MODIFICATION #3 – Option A (Proposed Condition)  
MODIFIED SECTION FROM PROJECT BOUNDARY TO WESTERLY ROUNDABOUT (W/ TRANSITION)

**Request for a  
Modification to a Road Standard  
and/or Project Conditions**

**Project Number:** TM 5571/5572 **Date of Request:** August 5, 2015

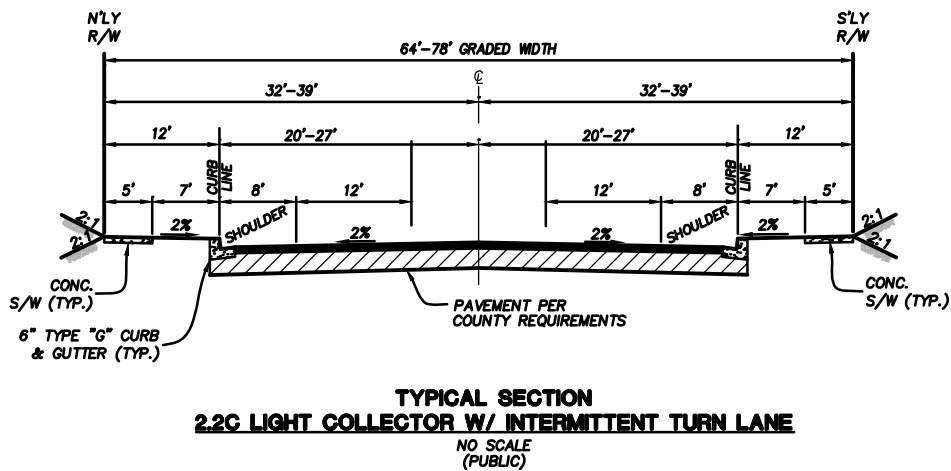
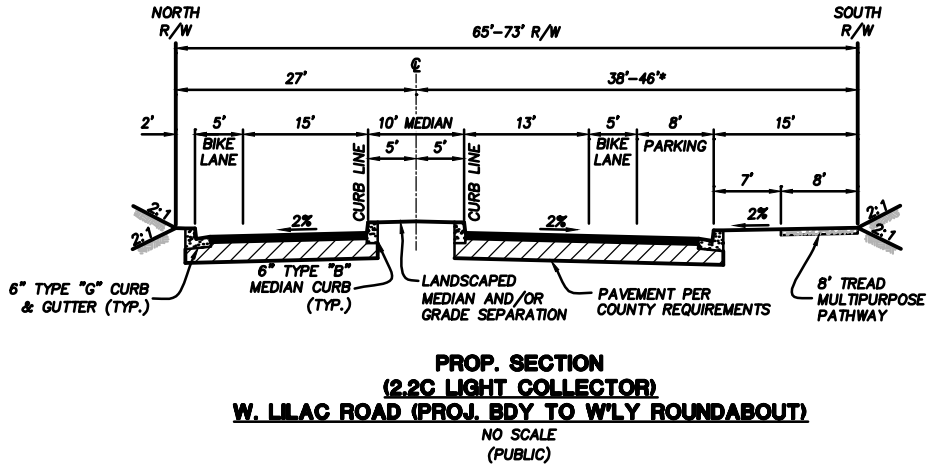
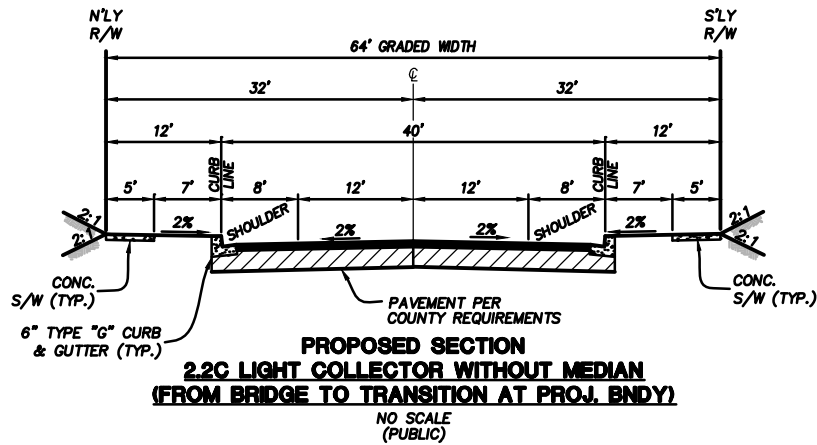
**Requested Modification (attach engineering sketches showing existing layout, details, and notes):** The standard road section for Light Collector Road 2.2C with an intermittent turn lane has a 54' wide curb to curb width on 78' ROW (64' with no turn lane), 8ft shoulders, and 12' pkwys. The requested modification to the road standard is to decrease the pkwy to a 2' pkwy along the north, add a proposed 10' median with 18' (with 5' bike lane) of pavement plus 8' parking along the south with increased 15' pkwy. West of this modification, the road section consists of the standard for 2.2C Light Collector without an intermittent turn lane, having 40' wide curb to curb width on 64' ROW, 8' shoulders, and 12' parkways. The modification request includes a transition from this typical section to the proposed, non-standard 2.2C Light Collector east of the subdivision boundary. The 320' transition safely handles the reduction of the northern pkwy from 12' to 2' and the introduction of a median.

**Reason for Modification (provide attachment if additional space is required):** The existing topography on each side of the existing graded road width is very steep in this area. Extensive off-site grading and habitat disturbance as well as the need for off-site condemnation to obtain off-site ROW. Permission to grade from adjacent land owners on both sides would be required to implement the standard roadway section (Light Collector 2.2c). West Lilac would operate at LOS D or better with or without the requested modification. The modification would provide additional parking onsite in front of rear entered lots, enhanced landscaping (w/ the median) through the project. The proposed median acts as a splitter for the proposed roundabout.

### WEST LILAC ROAD - PROJECT BOUNDARY TO WESTERLY ROUNDABOUT

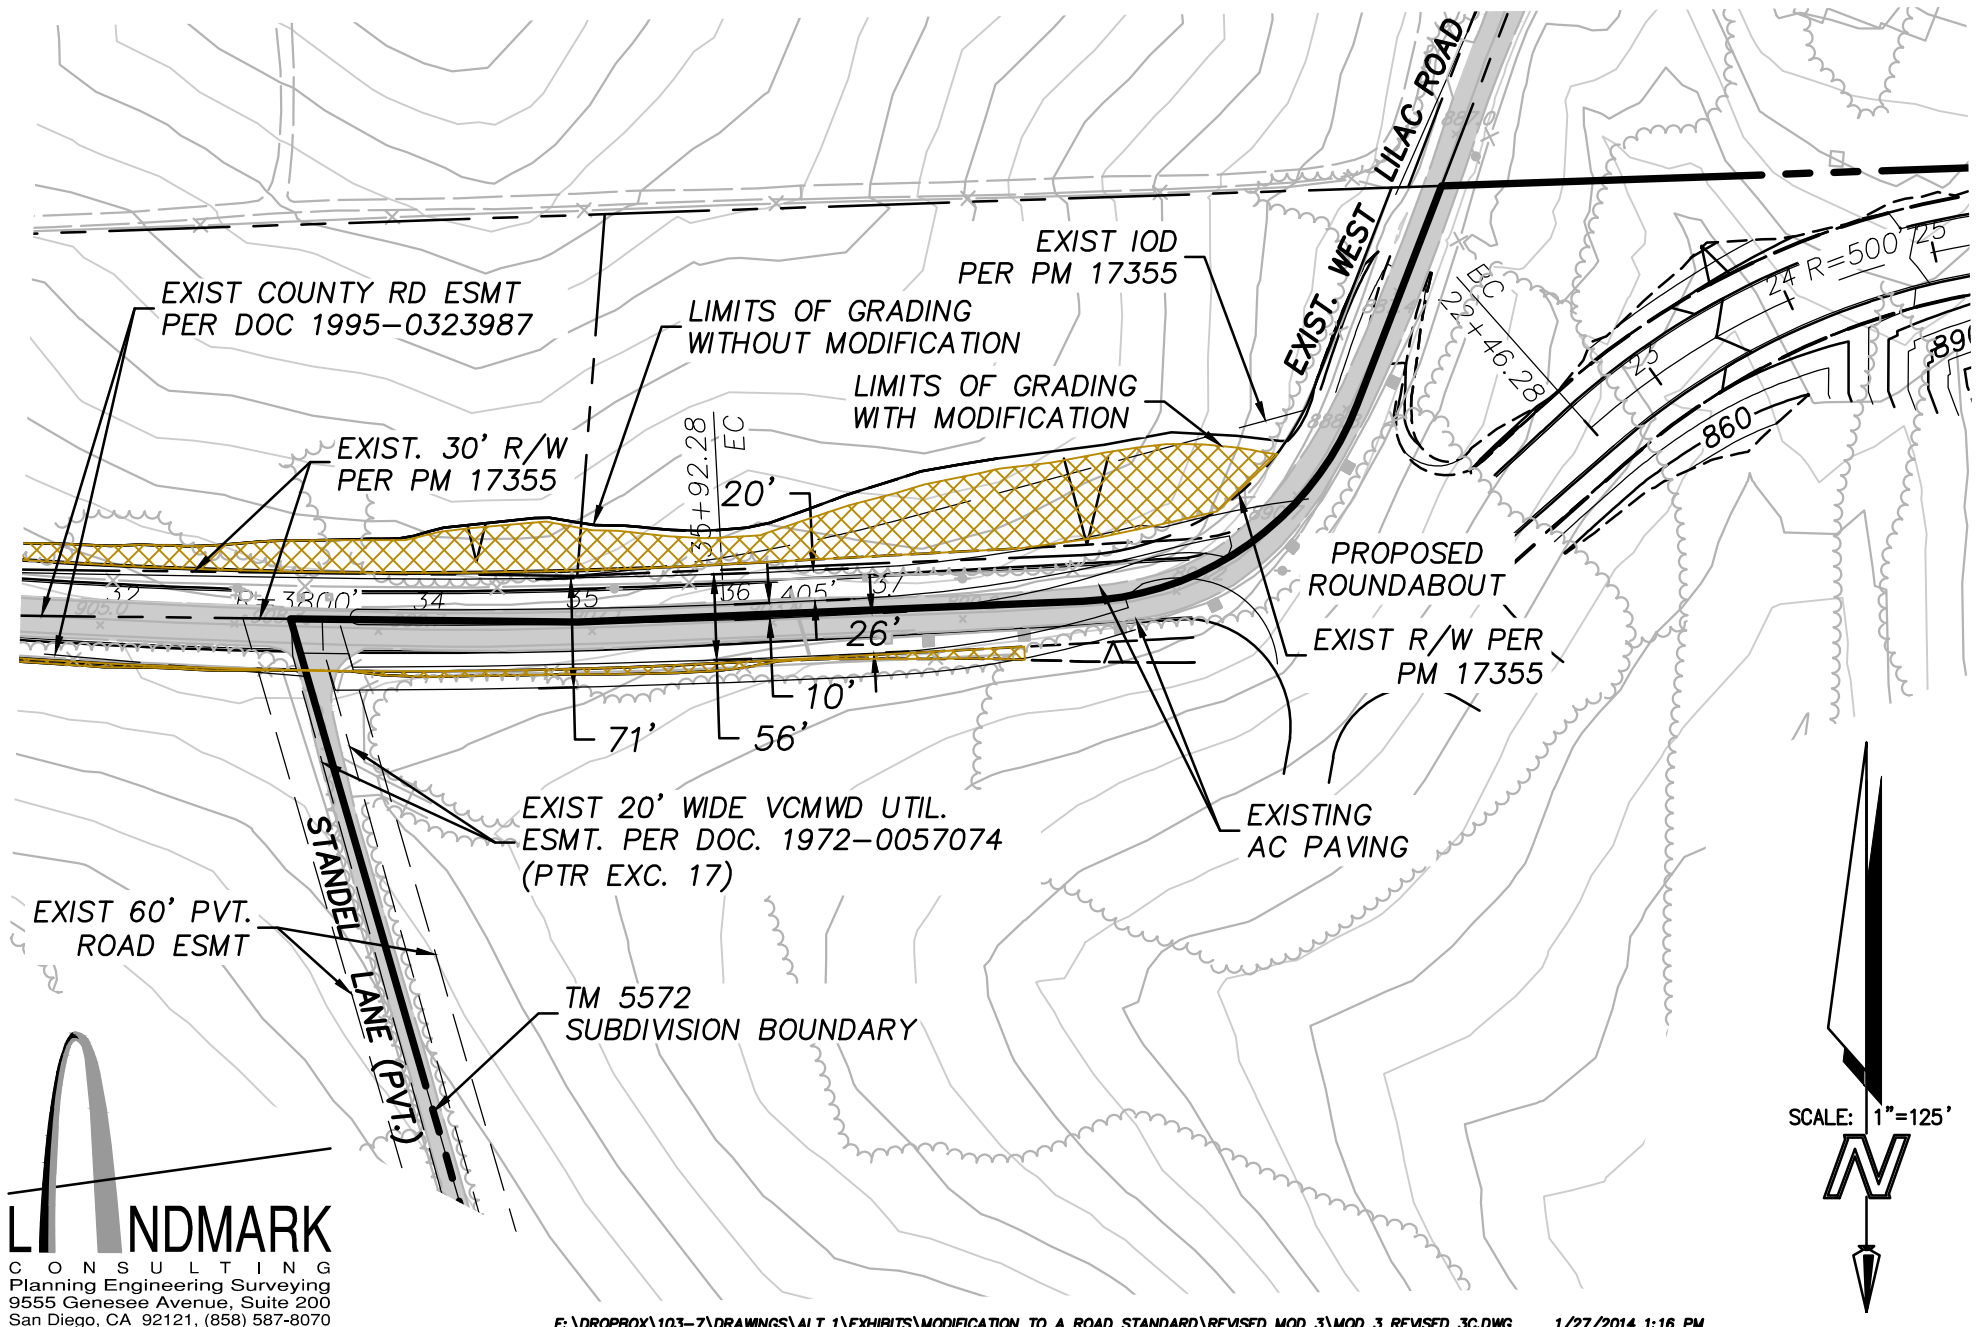
## WITH MODIFICATION REQUEST #3

### WEST LILAC ROAD TRANSITION DETAIL

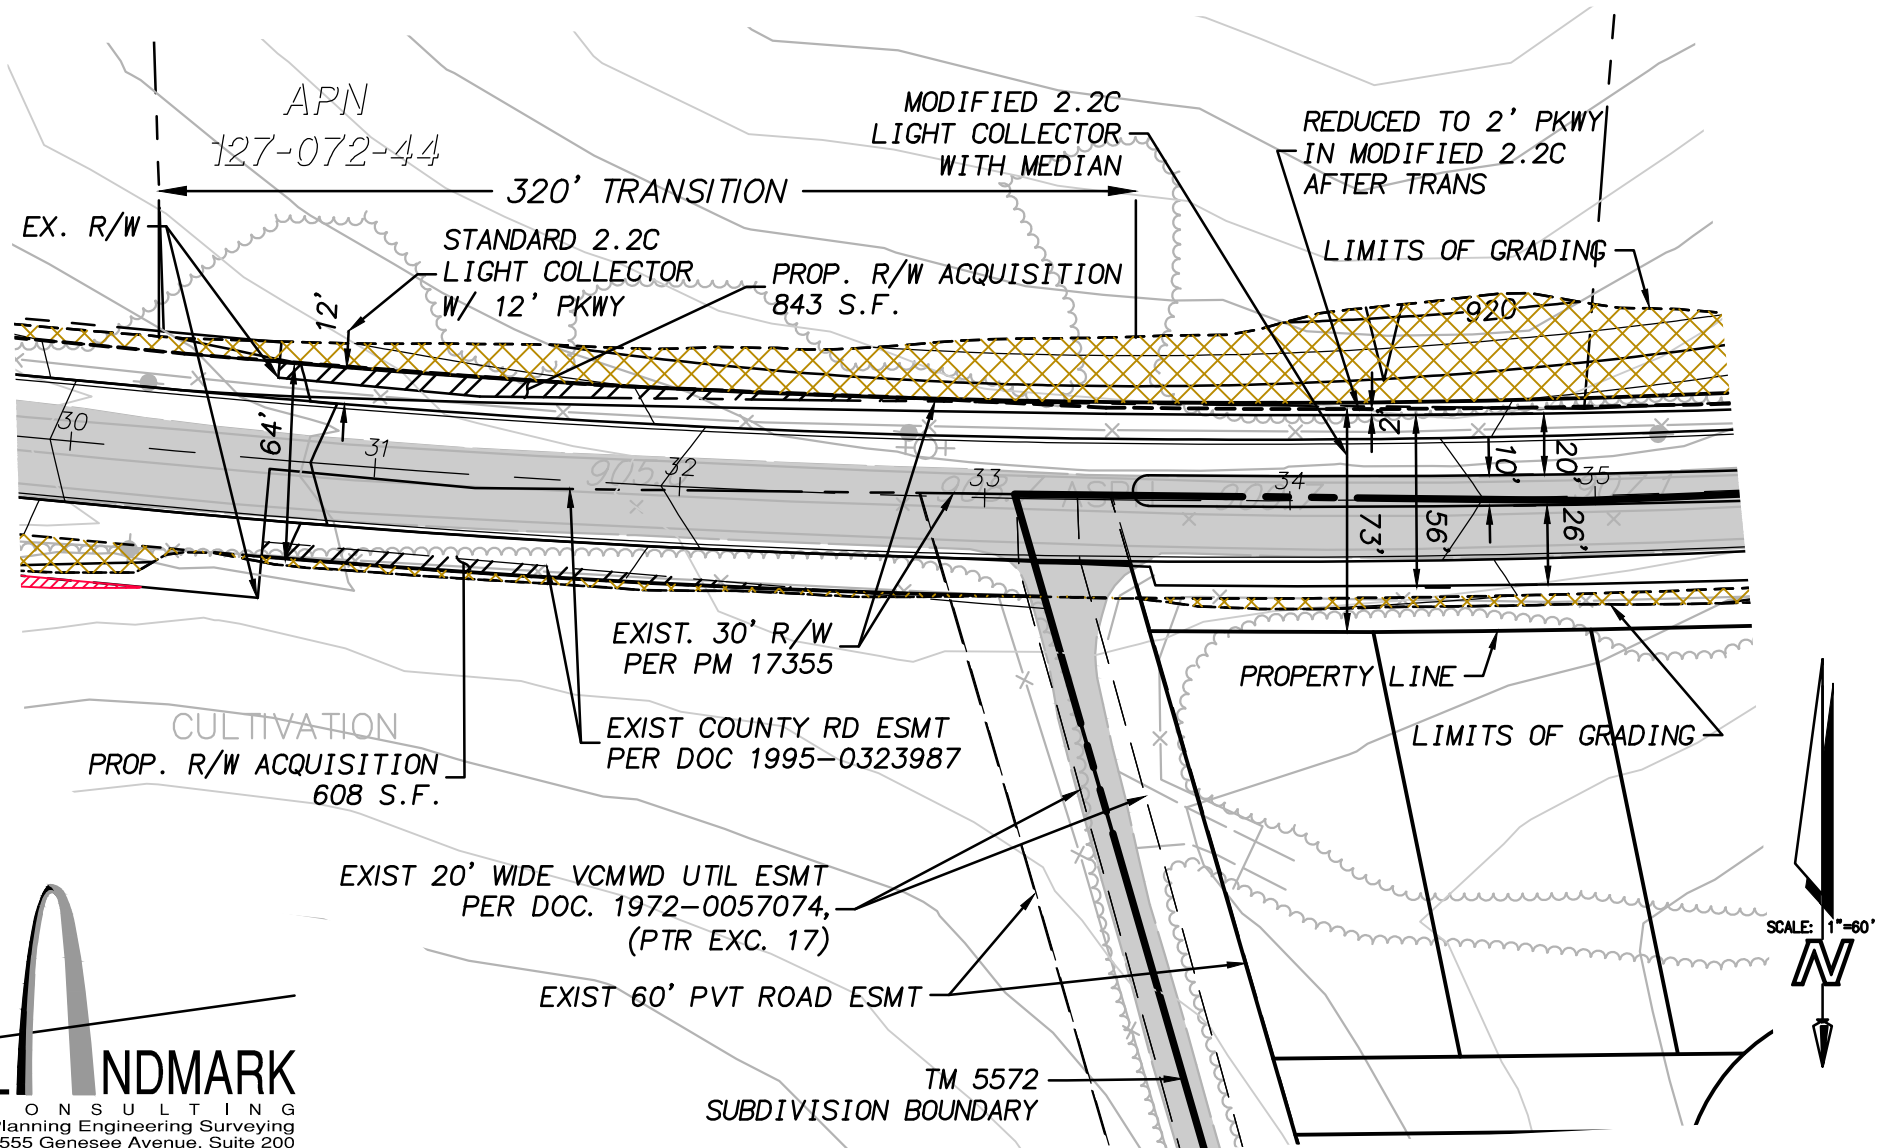
## MODIFICATION REQUEST #3
